INNER WEST

Engagement outcomes report GreenWay Missing Links Draft Design Plan

Figure 3:
The proposed raised crossing of Terrace Road near the junction with Ewart St, Dulwich Hill by EWPCCL does not reference the important junction with the GreenWay and the GreenWay north of the railway line is not shown on the plans.
(Source: Sydney Metro)

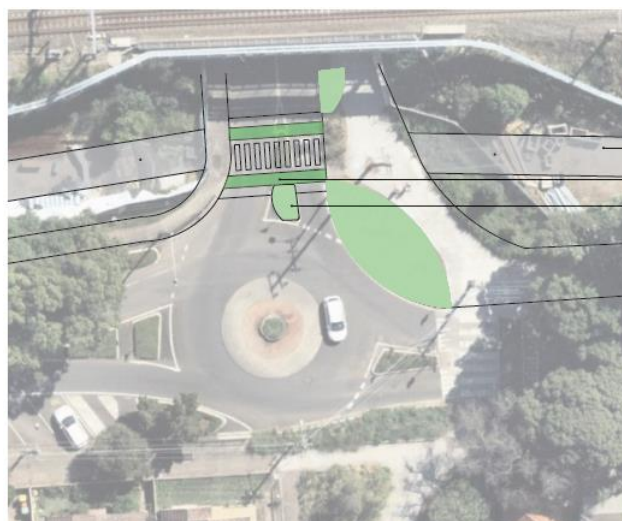
- The East West Pedestrian and Cycle Link (EWPC) that will be delivered by Sydney Metro is not shown or discussed in the GreenWay documentation (Figure 2), and the Greenway has not been indicated in preliminary plans for EWPC (Figure 3).

It is important that the two projects speak to each other and create a clear and safe intersection where path users can move from one corridor to the other.

Figure 4: Extract from Inner West Council's strategic bike network (left), as established in the 2022 draft Cycling Strategy. This clarifies the key strategic routes across the LGA. The GreenWay corridor is highlighted in green (Source: Inner West Council)

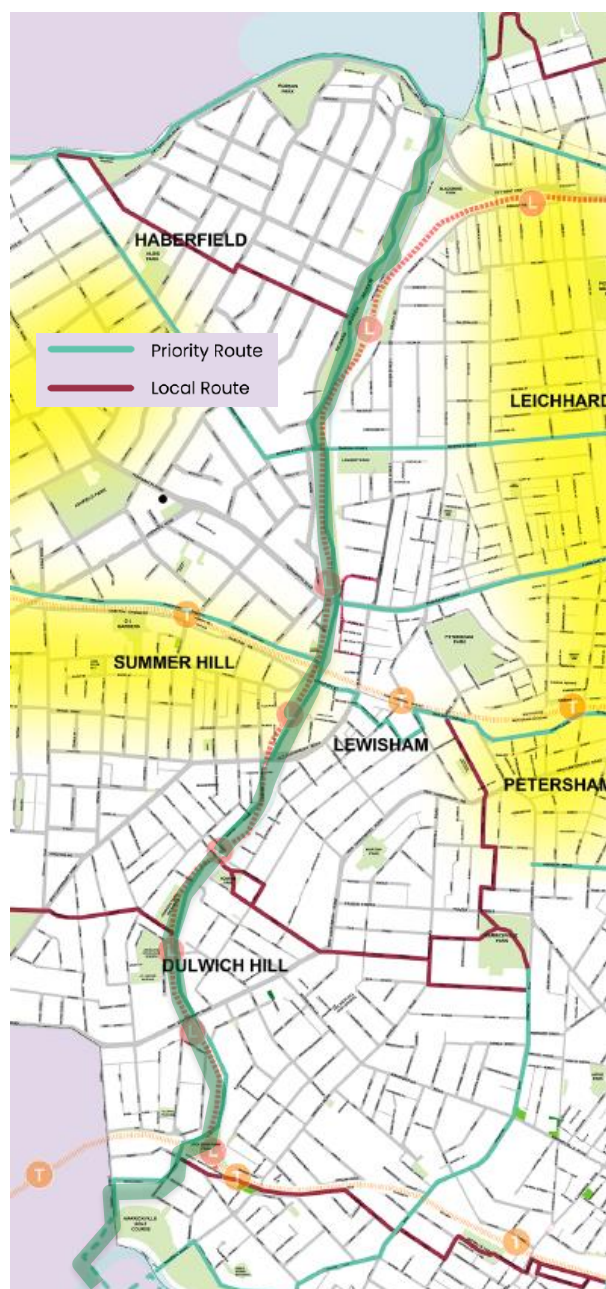
- The design drawings do not indicate safe and rideable connections to all of the significant bike routes that intersect with the GreenWay corridor.

As shown in Figure 2, key east-west routes cross the GreenWay at Parramatta Road, Grosvenor Crescent and Longport St, Davis St, Constitution Road, and as discussed, EWPCL near Ewart Street. Figure 3 indicates more local routes that will be considered for the future network.

Figure 5: A draft updated network plan which includes more local routes. The GreenWay corridor is highlighted in green. (Source: Inner West Council)

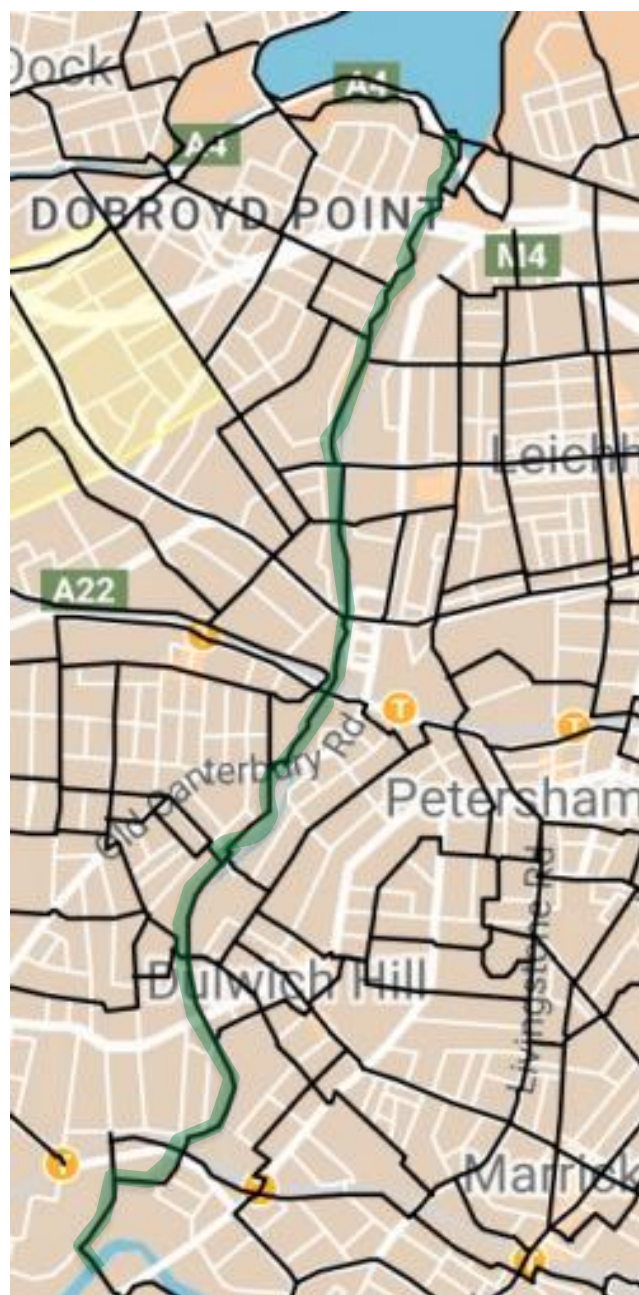
The GreenWay was conceived as a “spine” that incorporates the “ribs” of the local network. However, the existing and proposed ribs are not explicitly identified in the documentation, and access to the corridor is not facilitated or improved at all crossover points. In particular, access to Davis Street is now via stairs, not a ramp as previously proposed.
